APPEAL SUMMARY

Appeal ID: 21950	Project Address: 3434 NE Sandy Blvd
Hearing Date: 10/2/19	Appellant Name: KEN MYERS
Case No.: B-011	Appellant Phone: 518-364-9914
Appeal Type: Building	Plans Examiner/Inspector: John Cooley
Project Type: commercial	Stories: 1 Occupancy: M, B, A-2 Construction Type: III-B
Building/Business Name: PICCONE'S CORNER MARKE	ET Fire Sprinklers: Yes - throughout
Appeal Involves: other: CODE	LUR or Permit Application No.: 19-127919-CO
Plan Submitted Option: pdf [File 1]	Proposed use: RETAIL/ BAR

#### Appeal item 1

PARTIAL FLOOR PLAN— DINING AREA

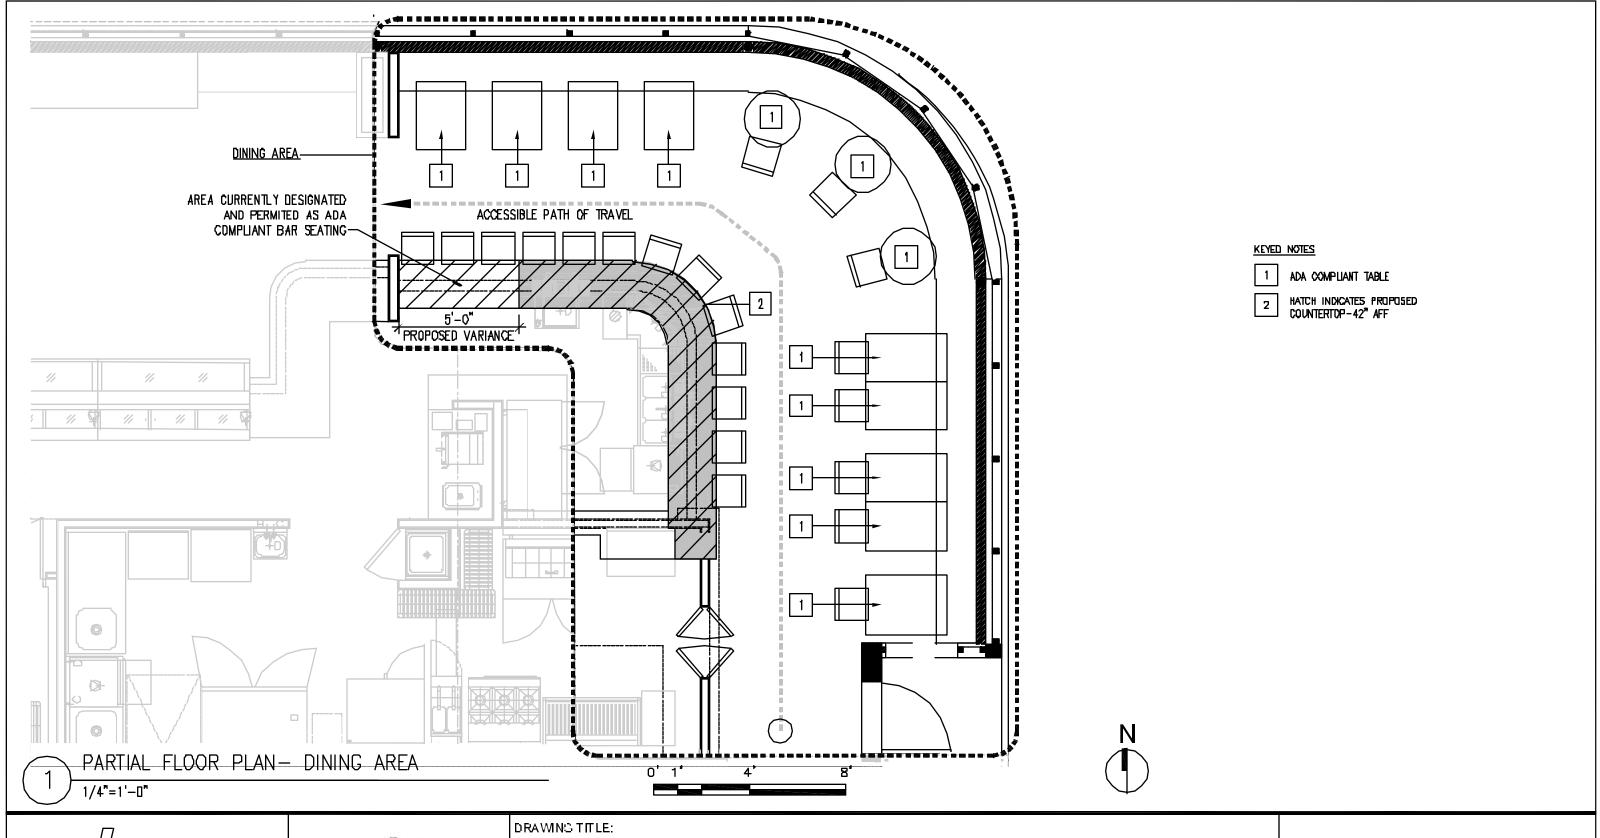
<b>Requires</b> That a section of the bar be at 34" tall for wheelchair acc	essibility.
---	-------------

#### **Proposed Design** We propose a height of 42" above finish floor for the entire bar top area, and that the remaining tables throughout the dining area to be Handicap accessible tables.

#### Reason for alternative The federal guidelines are as follows:

28 Code of Federal Regulations (CFR) part 36, 5.2 Counters and Bars- Where food or drink is served at counters exceeding 34 in (865 mm) in height for consumption by customers seated on stools or standing at the counter, a portion of the main counter which is 60 in (1525 mm) in length minimum shall be provided in compliance with 4.32 or service shall be available at accessible tables within the same area.

All additional tables provided within the facility will be at an accessible height and equal services will be provided throughout. As we are in compliance with the federal guidelines we feel that we are also complying with the intent of this code.

In addition to this the following appeals: appeal ID 6985 from 04/08/10, appeal ID 7208 from 07/08/10, and Appeal ID: 18979 from 03/07/19 have been reviewed and granted in similar cases.

Omission of accessible bar space: Denied. Proposal does not provide an equivalent level of accessibility. Appellant may contact John Butler (503 823-7339) with questions.
